**PLANNING COMMISSION AGENDA**

Tuesday, February 07, 2017  
Breckenridge Council Chambers  
150 Ski Hill Road

**Subject:** Lincoln Park at the Wellington Neighborhood Phase II, Master Plan Minor Modification (8th Master Plan Amendment of Wellington Neighborhood Master Plan, 1<sup>st</sup> modification of Lincoln Park Master Plan)  
(Class C; PL-2016-0617)

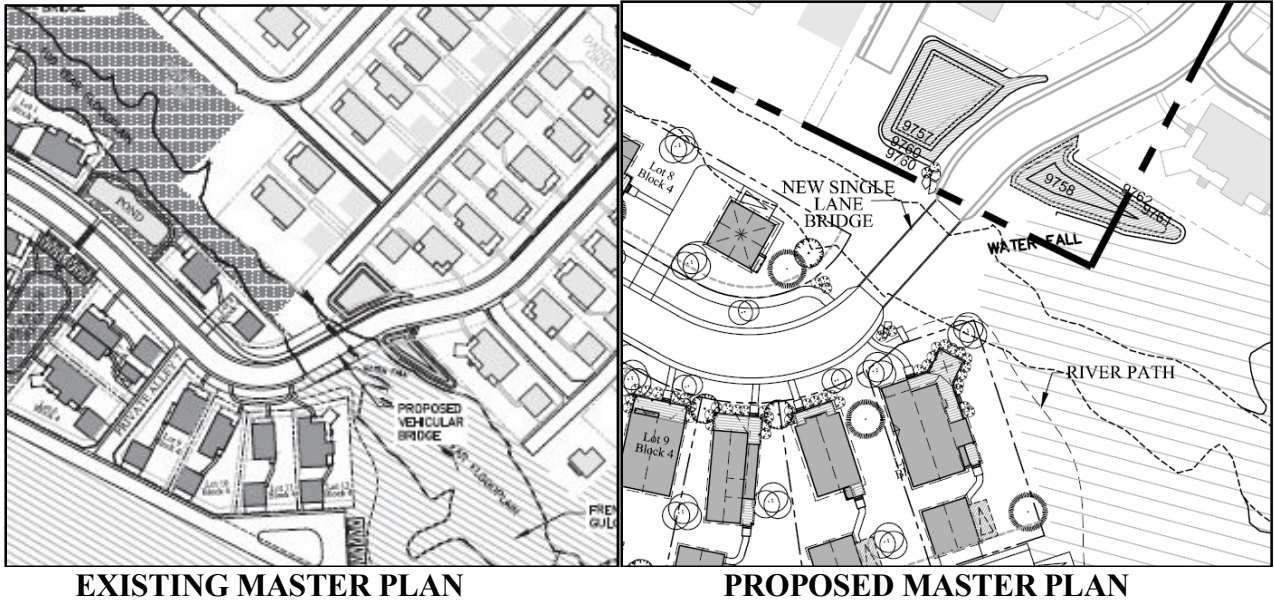
With this master plan modification, the applicant has proposed a narrowed one-lane vehicular bridge measuring 15-foot wide rather than a typical 26 foot wide bridge as approved for Lincoln Park in 2015 (see comparison depiction below).

This narrow width allows for traffic calming at the neighborhood bridge connection which would require drivers to pull off to the side, stopping or slowing down for any oncoming vehicles or pedestrians. Engineering staff is supportive of the proposed vehicular bridge as designed. Red, White and Blue Fire Department are also supportive of the design. Detail on this connection will be reviewed by the Engineering Department with the Subdivision submittal in Phase 4.

Staff is supportive of this added measure to calm the traffic with this minor master plan modification.

### Pedestrian Connections

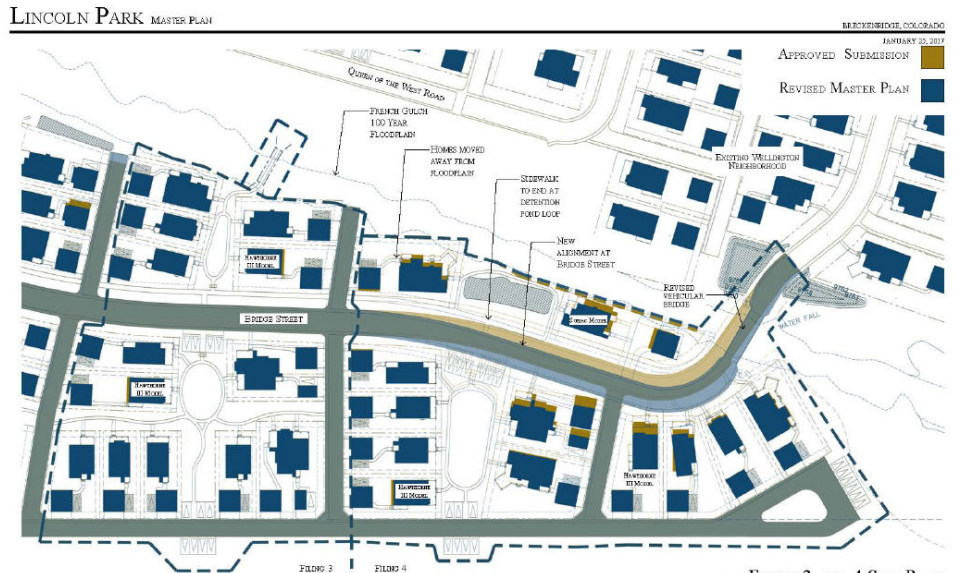
Including the vehicular bridge, there are four ways for pedestrians to cross French Creek. The pedestrian connections have not changed from the previous master plan, although the sidewalk was removed from the vehicular bridge to create a narrow bridge. There are no sidewalks on the Wellington Neighborhood side of French Creek for the sidewalk to connect to, but the sidewalk is continuous along Bridge Street in the Lincoln Park neighborhood. The change proposed with this minor master plan amendment is that the sidewalk does not continue across the vehicular bridge.

Staff is supportive of the proposed vehicular connection and notes that the extension and continuation of the existing right of way and the three foot bridges across French Creek are unchanged with this minor master plan amendment and are consistent with the previously approved Master Plans. Staff has no concerns.
